Iowa Statewide Interoperable Communications System (ISICS)
Standards, Protocols, Procedures

ISICS Standard:	Standard #:	2.12.6
Over the Air Rekeying	Date Adopted:	06/09/2022
	Date Reviewed:	
	Version:

Proposed Changes to Regional and Statewide Interoperable Talkgroup Fleetmap

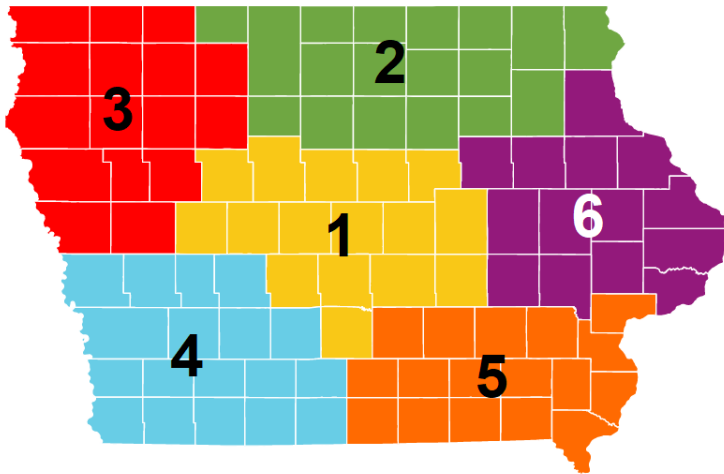
IATAC7	~~IATAC7~~	R1 TAC17	~~R1TAC17~~	R2TAC27	~~R2TAC27~~	R3TAC37	~~R3TAC37~~	R4TAC47	~~R4TAC47~~	R5TAC57	~~R5TAC57~~	R6TAC67	~~R6TAC67~~	Delete	
IATAC8	~~IATAC8~~	R1 TAC18	~~R1TAC18~~	R2TAC28	~~R2TAC28~~	R3TAC38	~~R3TAC38~~	R4TAC48	~~R4TAC48~~	R5TAC58	~~R5TAC58~~	R6TAC68	~~R6TAC68~~		
IATAC9	~~IATAC9~~	R1 TAC19	~~R1TAC19~~	R2TAC29	~~R2TAC29~~	R3TAC39	~~R3TAC39~~	R4TAC49	~~R4TAC49~~	R5TAC59	~~R5TAC59~~	R6TAC69	~~R6TAC69~~		
	IATAC70E		R1TAC71E		R2TAC72E		R3TAC73E		R4TAC74E		R5TAC75E		R6TAC76E	Add	Public Safety Only
	IATAC80E		R1TAC81E		R2TAC82E		R3TAC83E		R4TAC84E		R5TAC85E		R6TAC86E		
	IATAC90E		R1TAC91E		R2TAC92E		R3TAC93E		R4TAC94E		R5TAC95E		R6TAC96E

These proposed changes affect the ISICS regional and statewide interoperability talkgroups. While there would be no difference in the total number of talkgroups, the current talkgroups ending in 7, 8 and 9 would be deactivated. The new encrypted talkgroups in the 70s, 80s and 90s would be new additions. The region number in the talkgroup name would be the last digit—e.g. R2 TAC72E, R2 TAC82E, R2 TAC92E. This change is to ensure that radios are appropriately updated to include the new secure interoperable talkgroups.

The proposed changes to the ISICS regional and statewide interoperability talkgroups would be considered effective 18 months after adoption in order to give agencies time to program and key their radios.
